SUBJECT : HEXAGON Sensor Subsystem Debriefing
Charts for Itak

1. Attached are copies of the briefing charts I plan to use in the 3 March 1967 HEXAGON Sensor Subsystem Debriefing for Itak.

ITEMFUNDAMENTAL PROBLEM AREAS

ITEK PROPOSAL DEFICIENCIES

GATE WIDTH FOR VARIOUS OPERATING CONDITIONS

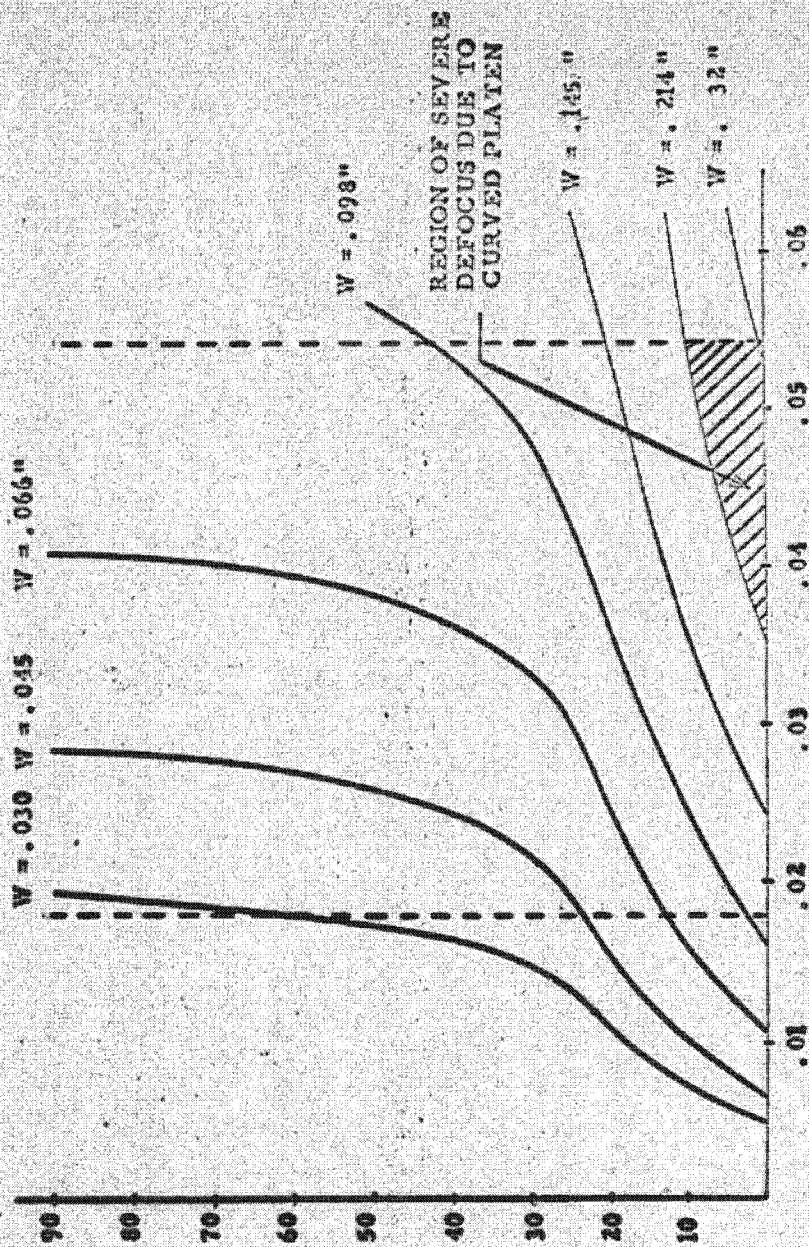
ITEM
CURVED PLATEN DEFOCUS EFFECT

ITER
FOLDING MIRROR TEMPERATURE
VERSUS TIME

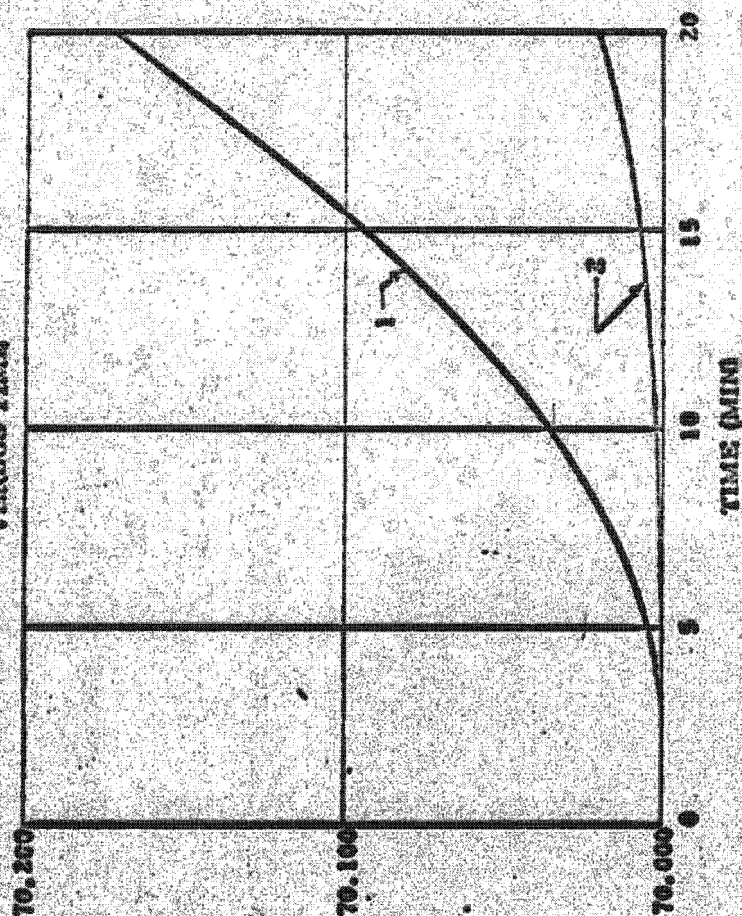
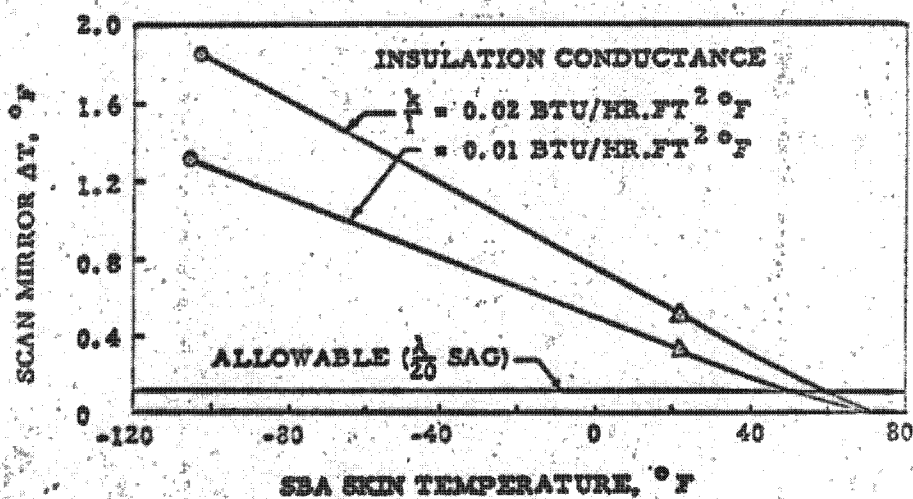
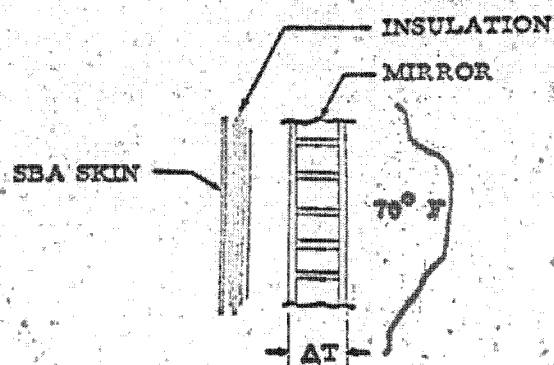
GRADIENT CAUSED BY HEATING FROM FILM DRIVE
ASSEMBLY

- THIS GRADIENT TENDS TO REDUCE DEFORMATION
CAUSED BY INCIDENT SOLAR ENERGY THROUGH THE
OPTICAL SYSTEM

PENTA PRISM STABILITY REQUIREMENTS

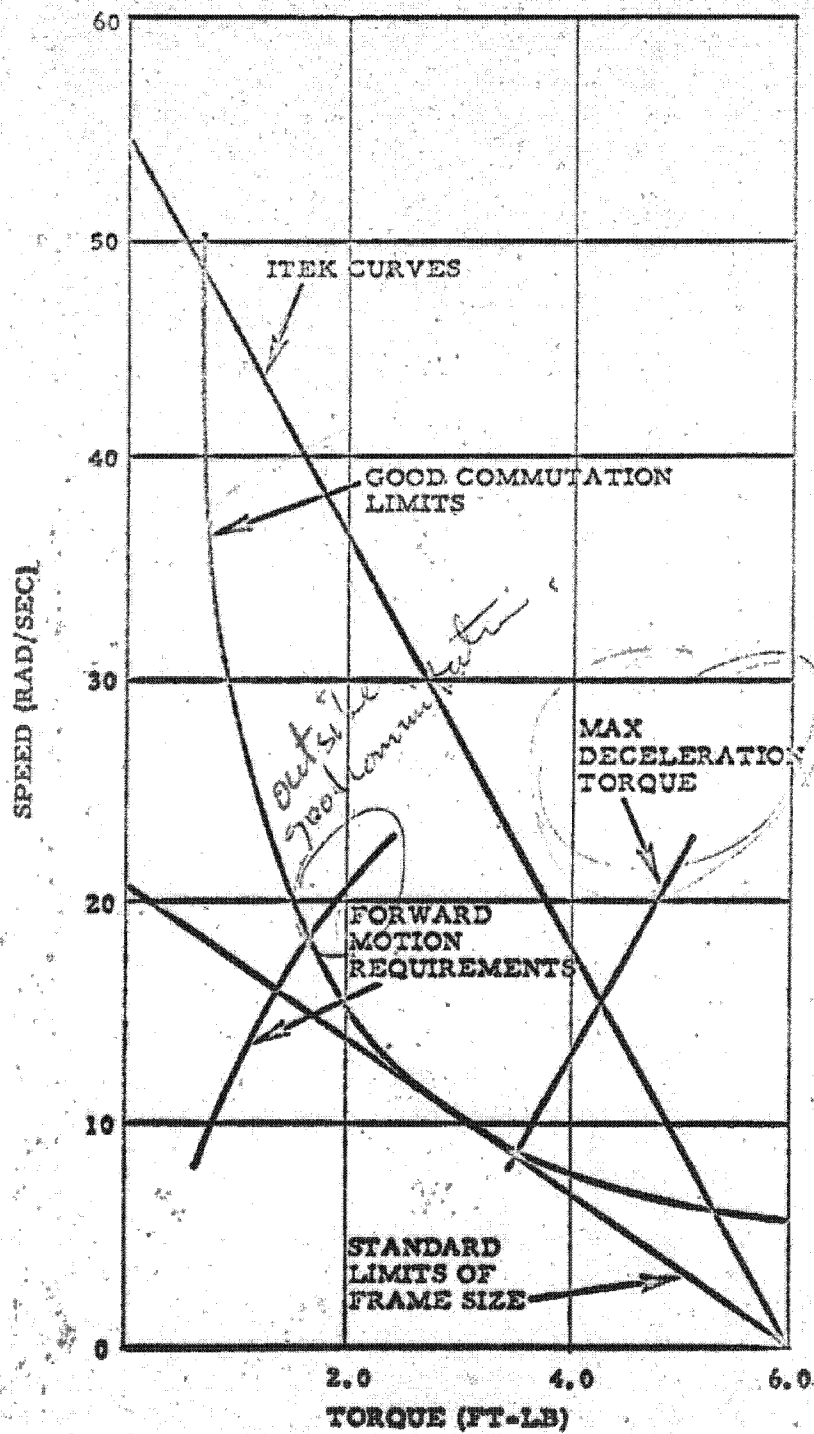
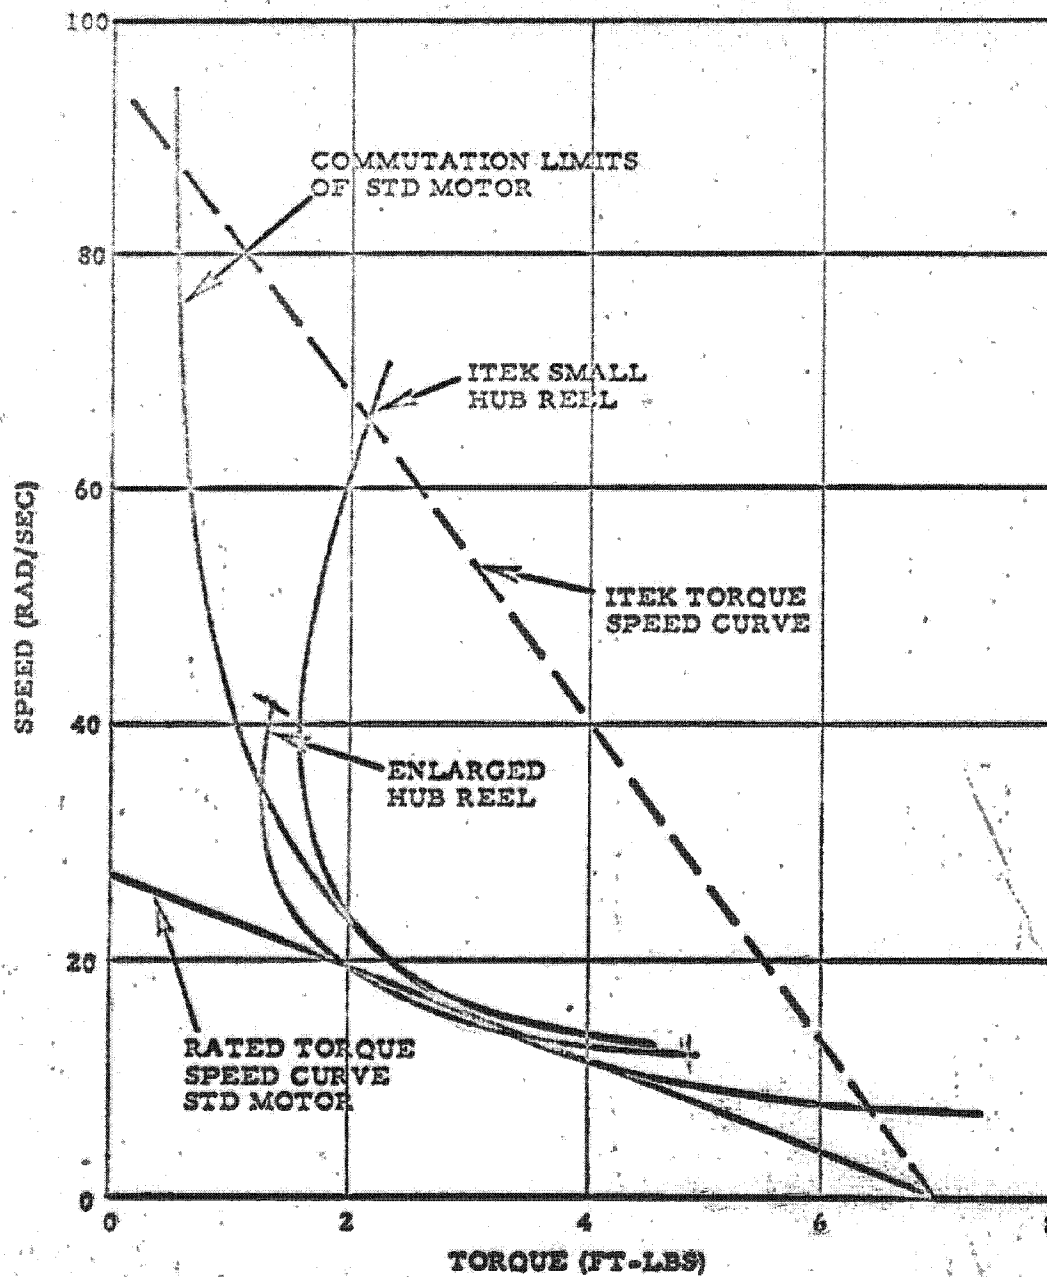
FOCAL SHIFT BUDGET ALLOWANCE = 2.2 MICRONS FOR TWO PENTAS

2. PRINCIPAL KNOWN CAUSE OF PENTA DEVIATION CHANGE IS TEMPERATURE VARIATION

3. FOCAL SHIFT FROM A SINGLE PENTA = 0.93 MICRON/°F FOR THE PROPOSED PENTA DESIGN

4. FOCAL SHIFT FOR TWO PENTAS = 1.86 MICRON/°F, ASSUMING SAME TEMPERATURE CHANGE FOR EACH PENTA

5. THERMAL CONTROL REQUIRED FOR PENTAS = $\pm 1.2^\circ\text{F}$. NEGLECTING PENTA DEVIATION CHANGES OTHER THAN THERMAL

6. A 1 MICRON FOCAL SHIFT CORRESPONDS TO 0.1 SEC RAY DEVIATION CHANGE FOR A SINGLE PENTA

ALTERNATE ITEX SV LAYOUT

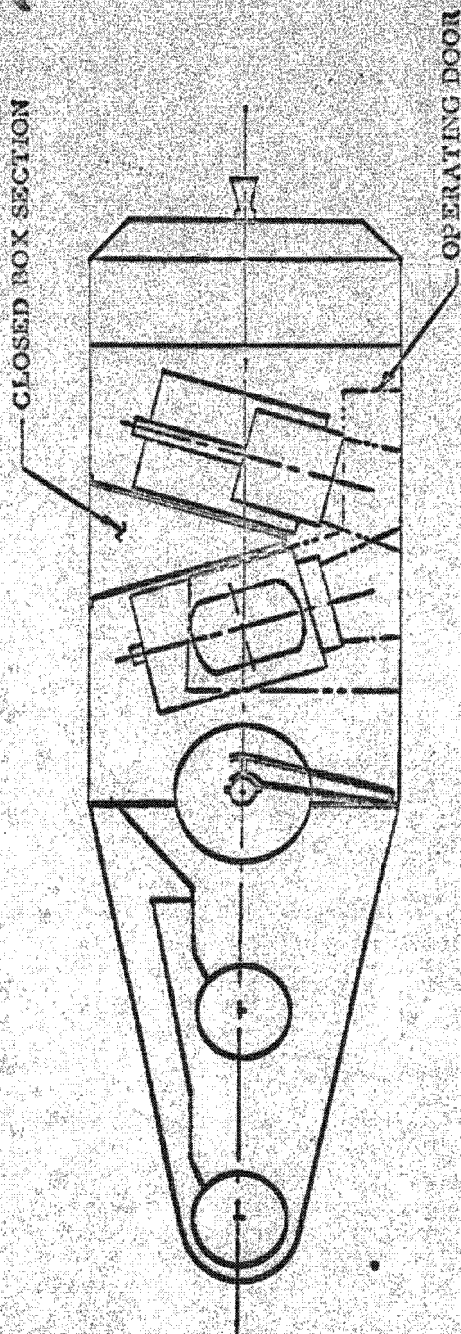
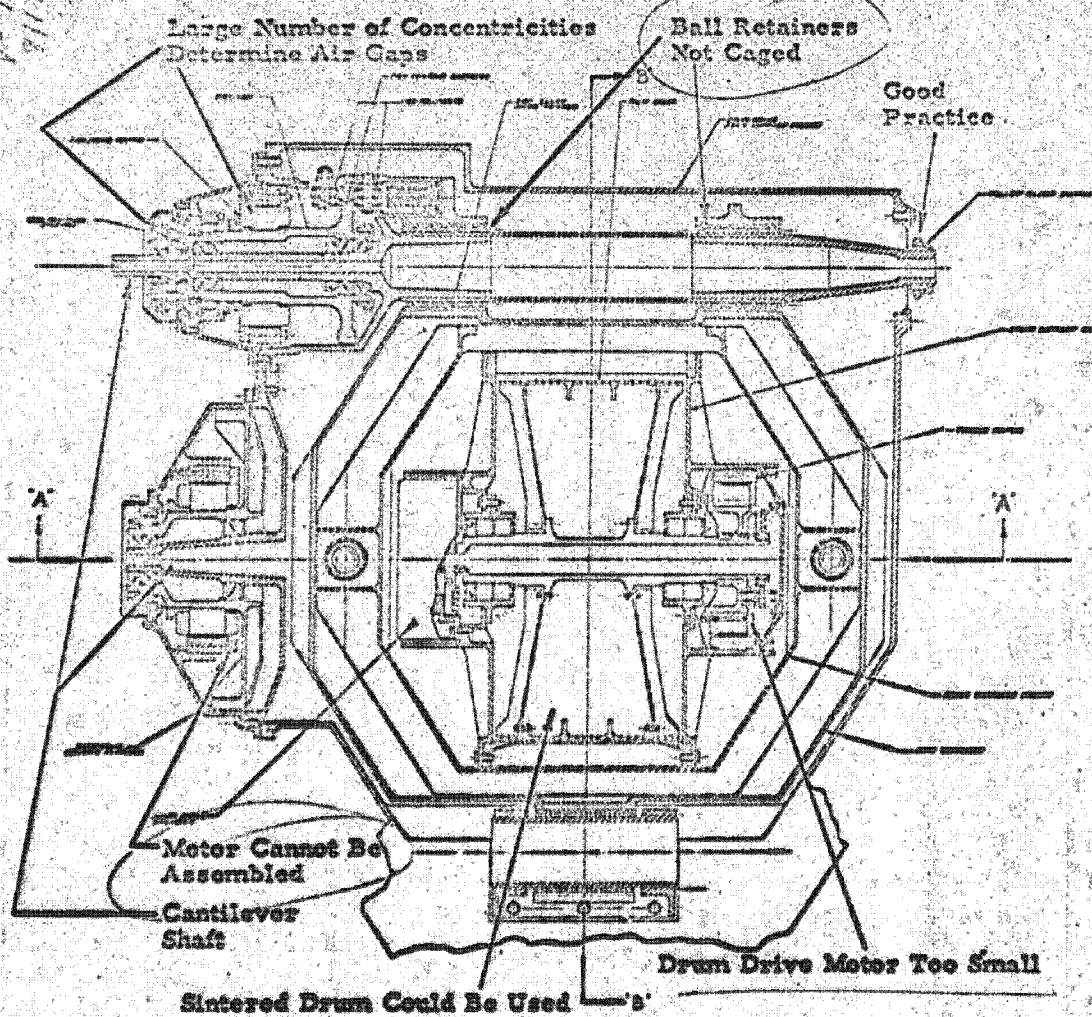
- ONE NON-LOAD CARRYING EJECTABLE STRUCTURE - EASIER DESIGN
- NO SEPARATION SHOCK LOADS - USE PIN-PULLERS/SPRINGS
- SHORT OPEN-SECTION PARTS OF STRUCTURE REQUIRE HEAVY DESIGN
- OPERATING DOOR TRAJECTORY IN YZ PLANE - EASIER DESIGN
- OPERATING DOORS EACH ~ 120° OF ARC
- CLOSED BOX SECTION SUPPORTS CAMERAS' ASCENT LOADS
- CLOSED BOX SECTION REDUCES INTER-CAMERA STRUCTURE WEIGHT

ITEK - FMC SERVO
TORQUE REJECTION CHARACTERISTIC

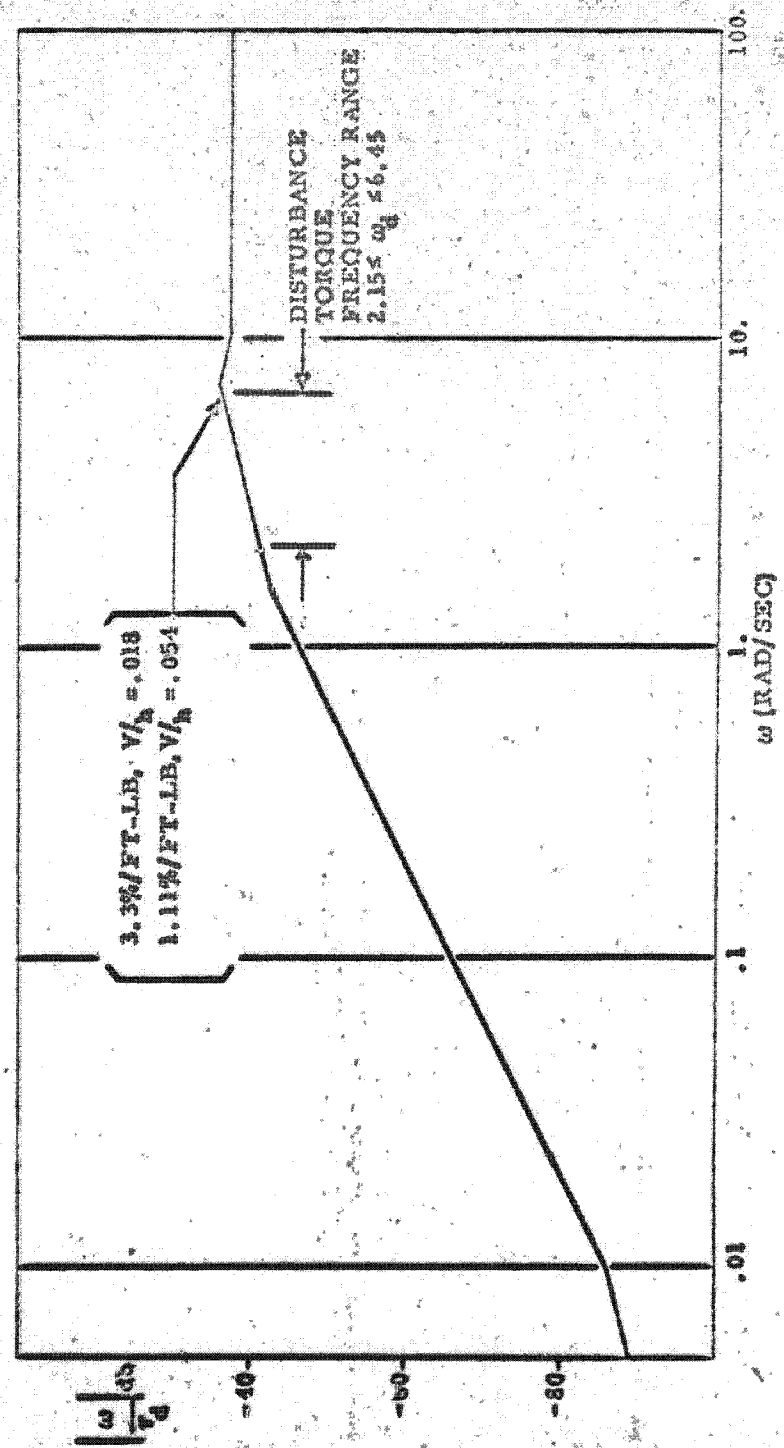
MAJOR ERROR SOURCES	ITEK ESTIMATE	TRW ESTIMATE OF ITEK SYSTEM	TRW ESTIMATE OF "BEST" SYSTEM
TACHOMETER	NONE AVAILABLE	.8%	.1%
SUMMING AMPLIFIER	"	.24%	.24%
DISTURBANCE TORQUE EFFECT	"	.9%	.1%
TOTAL SERVO PERFORMANCE (RSS)	.12%	1.23%	.244%
REQUIRED SERVO PERFORMANCE	.12%	.25%	.25%

ITEK REEL SERVO EVALUATION

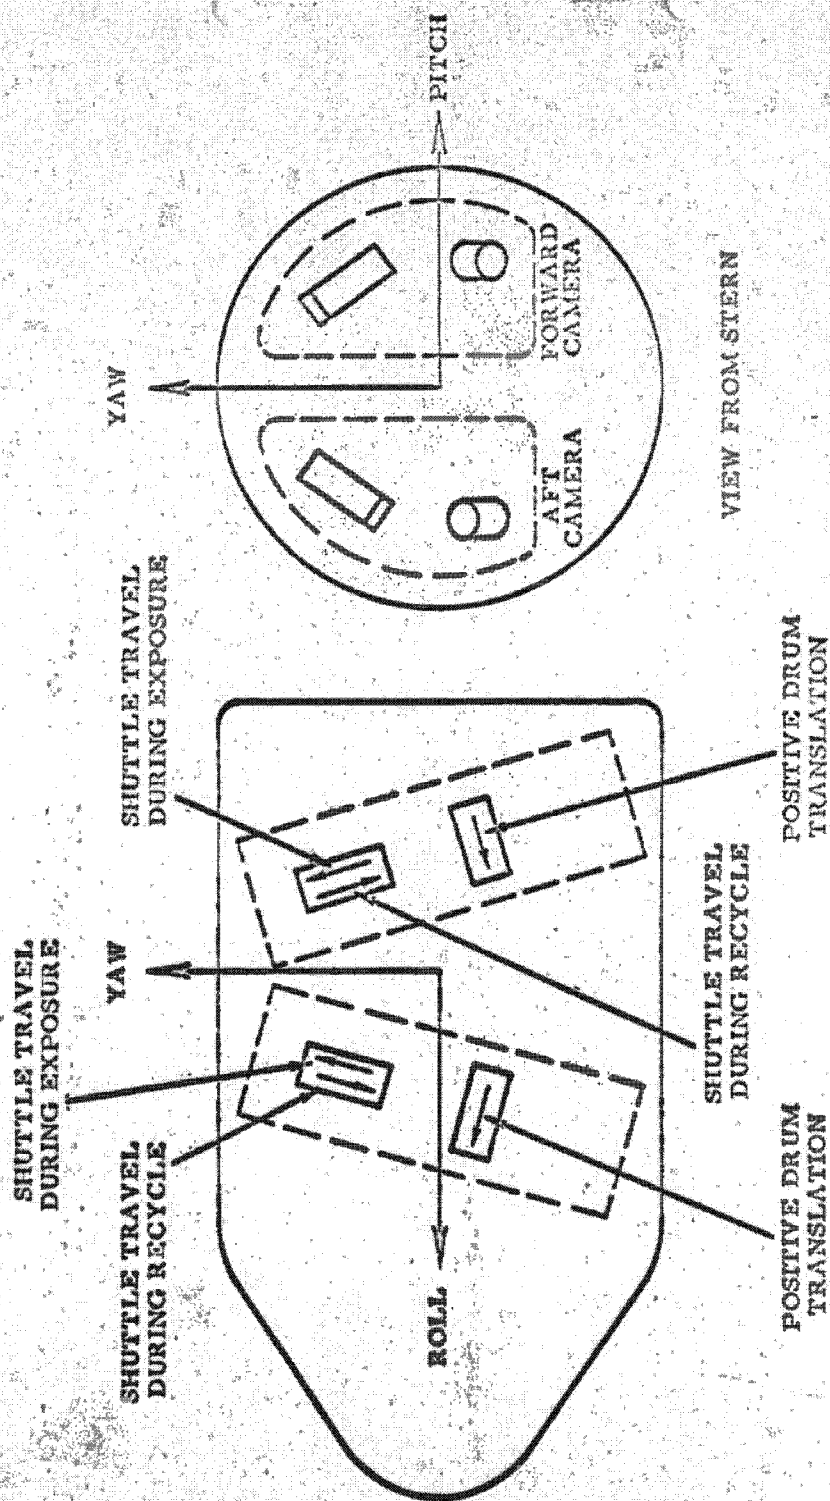
- ① LINEAR DESIGN
- ② PROVIDES ADEQUATE STABILITY OVER LARGE RANGES OF SPOOL RADIUS AND INTERIA
- ③ LEADS TO PRACTICAL, SIMPLE MECHANIZATION

- ① INADEQUATE MOTOR SIZING
- ② NO ROOM FOR GROWTH BEYOND 30-DAY MISSION WITH PRESENT CONCEPTS
- ③ ABSENCE OF TACHS ON SPOOL SHAFT POSES RELIABILITY PROBLEM

- ① SYSTEM DESIGN AND ANALYSIS POORLY PRESENTED
- ② DUAL MODE (NORMAL-CORRECTION) BEHAVIOR NOT ANALYZED
- ③ READY MODE BIAS OMITTED
- ④ SPOOL HUB RADII TOO SMALL
